THE R2-D2 BUILDERS CLUB

R2.0

What is R2.0?

Dave's *Not-Quite-So-Large* Data Port

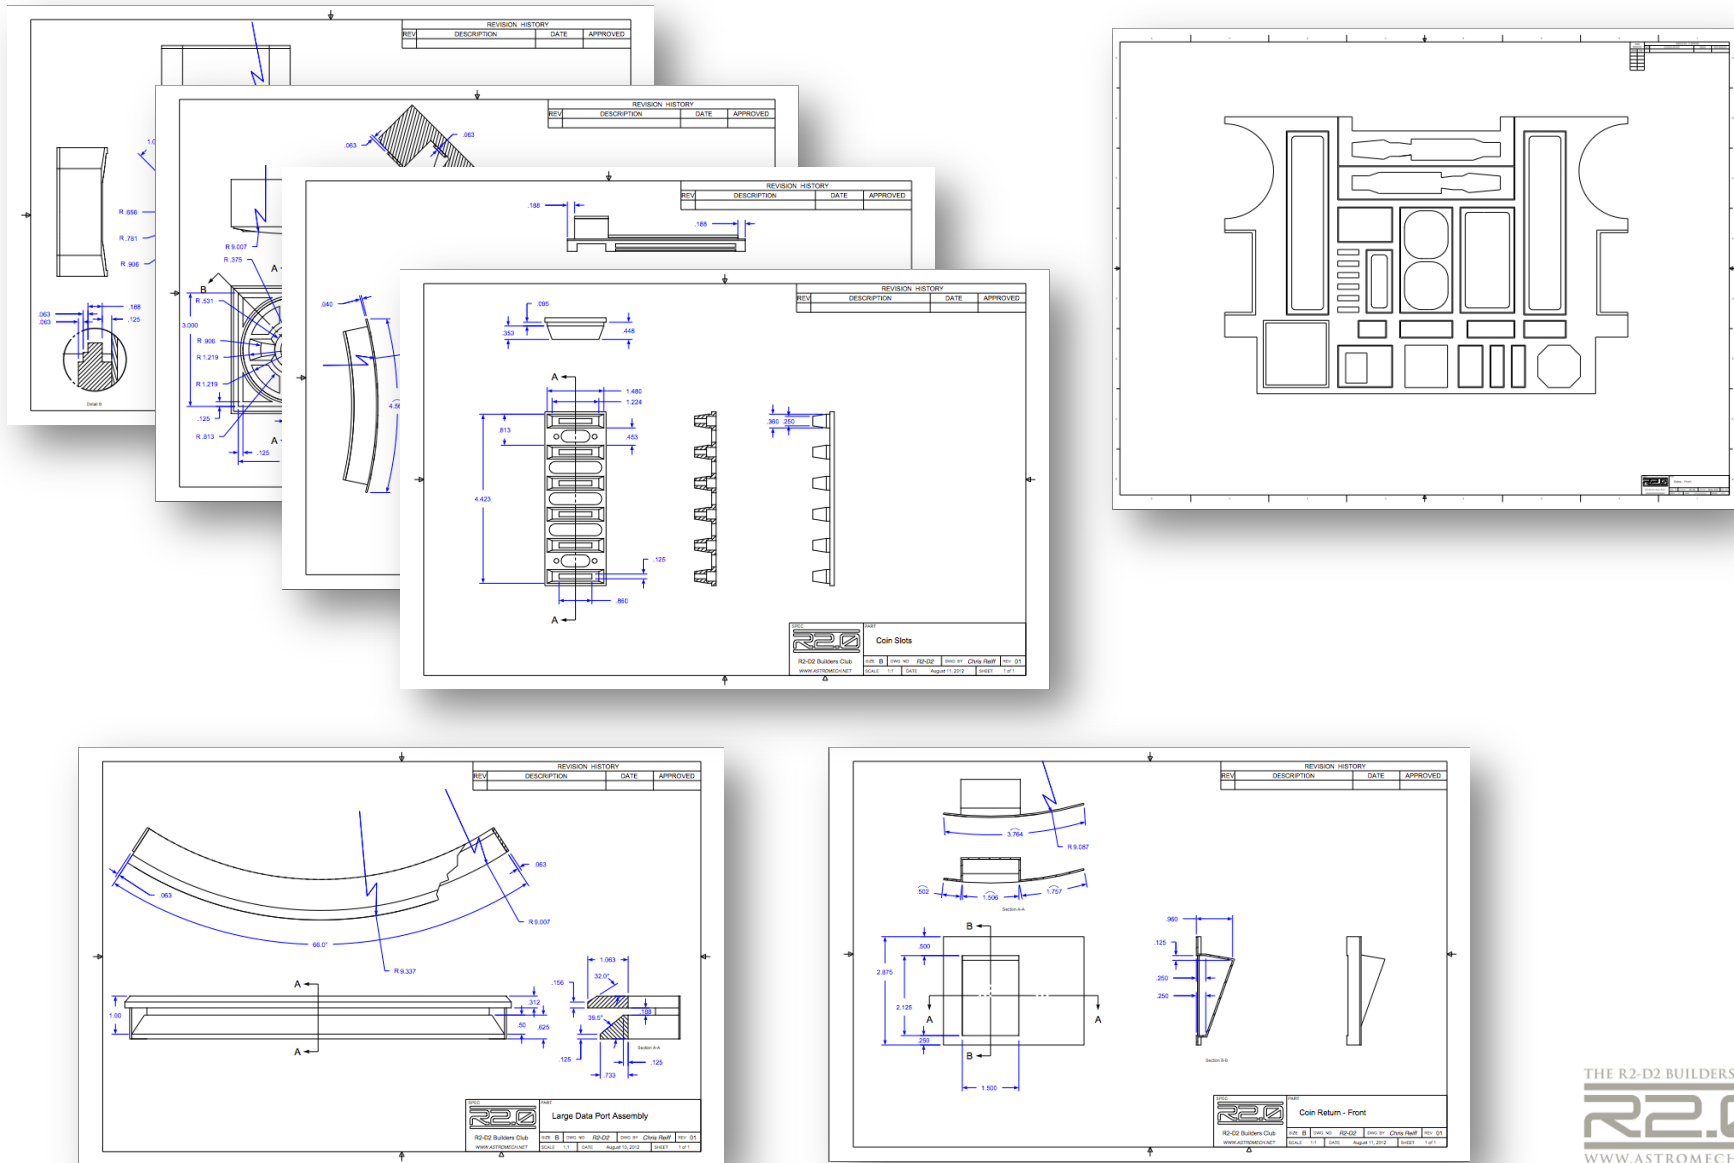
- Club Spec calls for a 1.180" tall data port
- Styrene Plans call for a 1" tall data port
- New Dimensions confirmed in reference
- Also found in production blueprints

When the Large Data Port is 1", other dimensions of the body must follow....

The Ankle Cylinder Conundrum

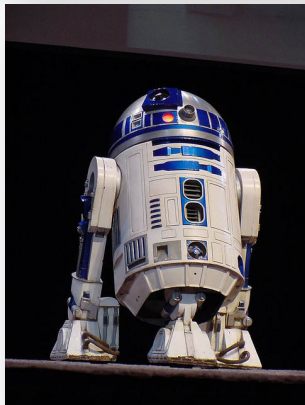
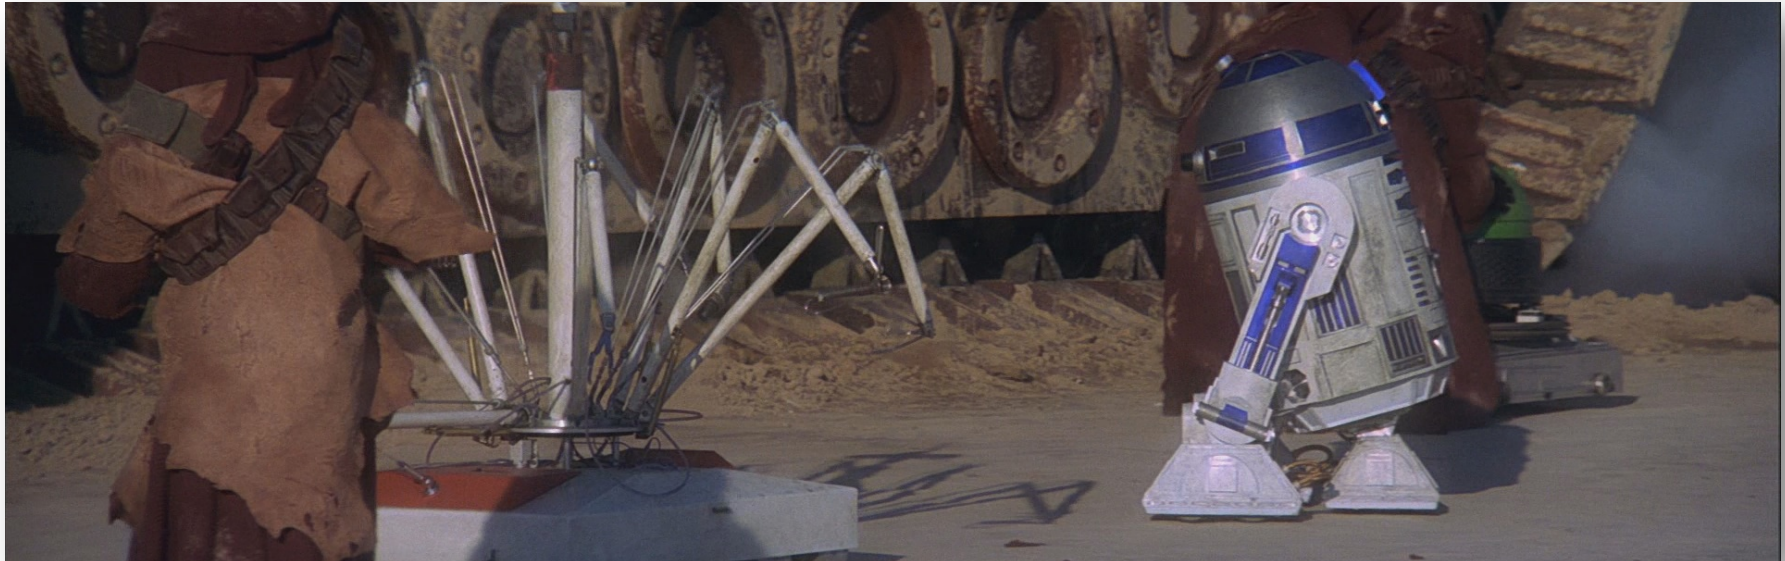
Center Ankle lengths can vary from droid to droid.

Most movie ankles have cylinders that stick out of the skirt a little more than half way.

Current body dimensions make this impossible while also maintaining the body angle. Our droids almost universally have center ankle cylinders that stick completely out from under the skirt.

Large Data Port Comparison

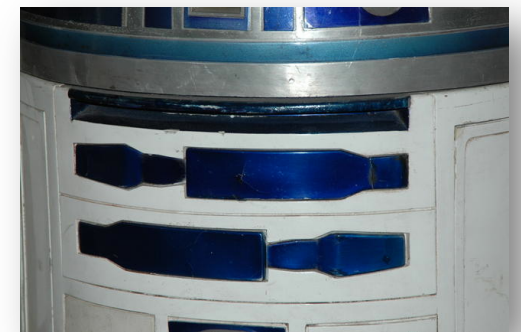
R2.0	Club Spec
Overall Height	1"	1.18"
Overall Length	66 Degrees	66 Degrees
Side Wall	Not Visible from Front	Visible from Front

Octagon port Comparison

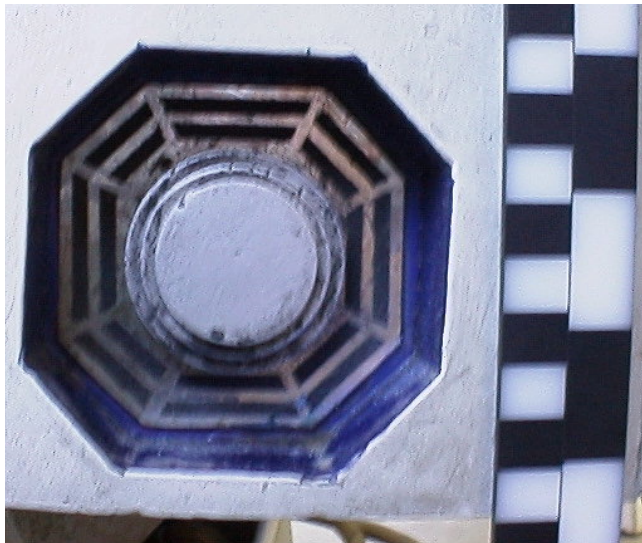
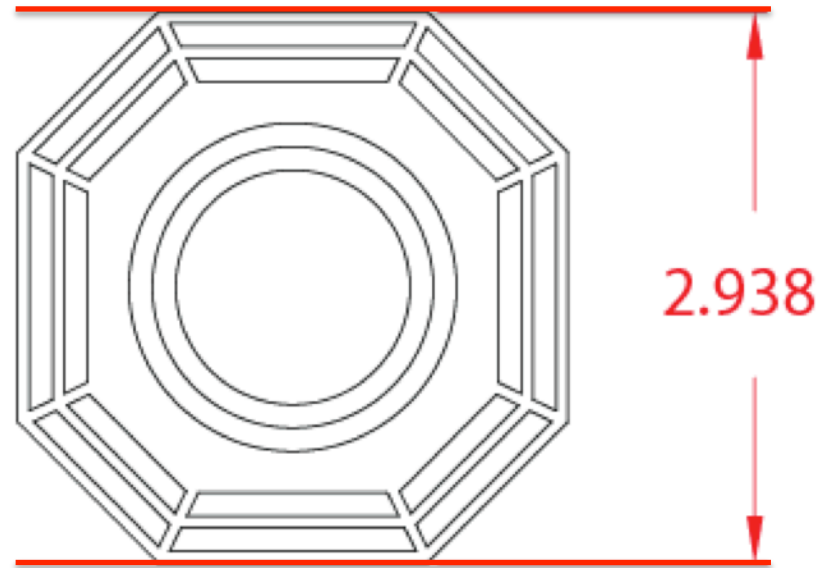
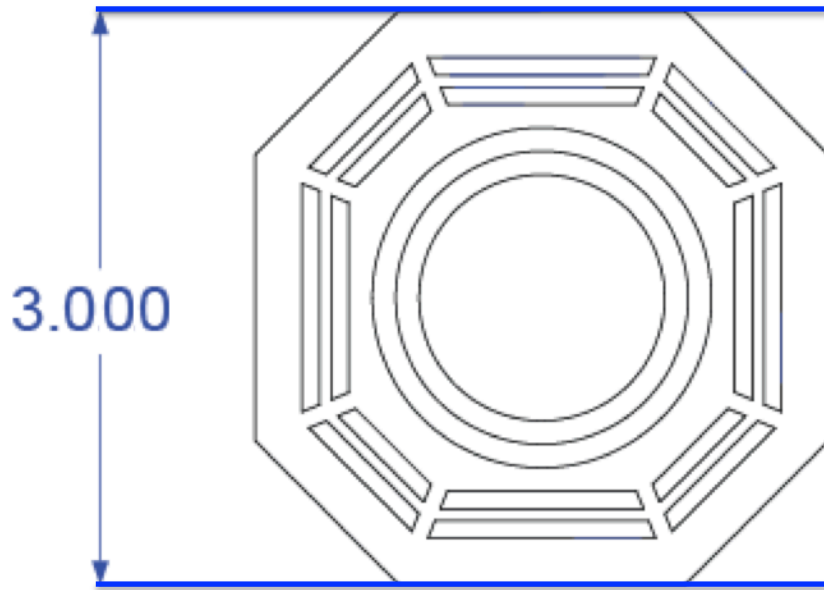
Confirmed via reference

Power Coupler Comparison

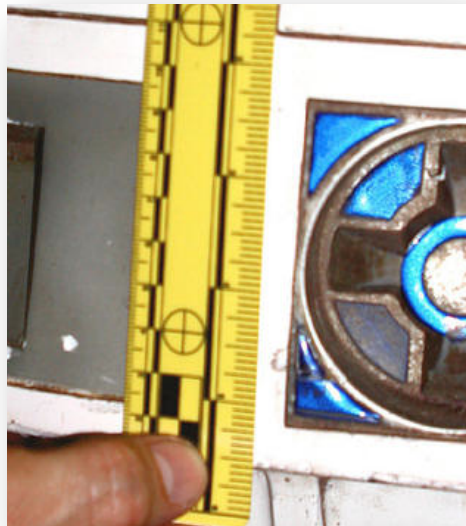
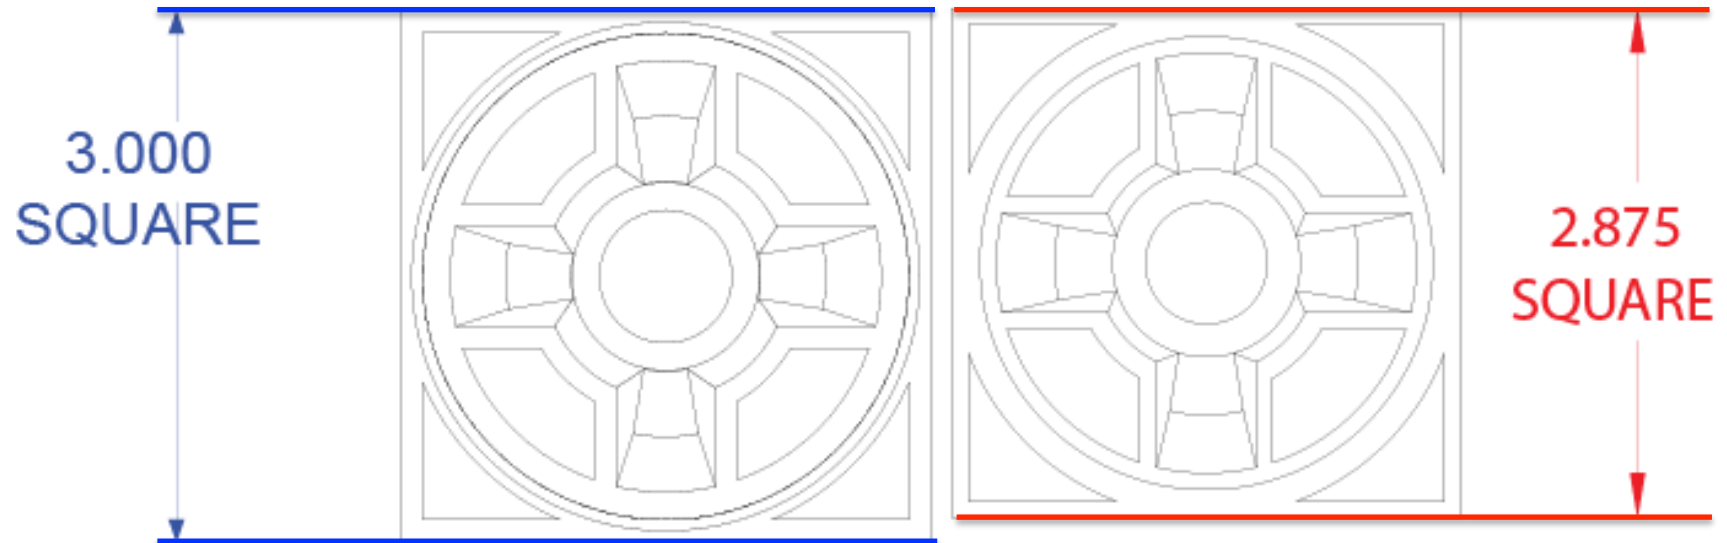
*Confirmed via ILM Uber Droid
reference, available on
Astromech.net*
